Access Compliance Report Public Rights-of-Way (Curb Ramps)

Intersection ID: 48944Main Street: LILLYSHIRE_PLCross Street: CALDWELL_RIDGE_PYLocation:SWADA ID: B3AEE6E8EB53Ramp Type: Combination2Initial Pass/Fail: FailOverall Compliance: NoSeverity Score:10

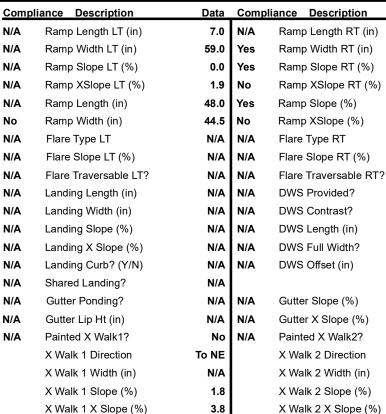
LT RP < 5%

Not Found, R304.5.1, R304.5.3

Remove & Replace Entire Ramp.
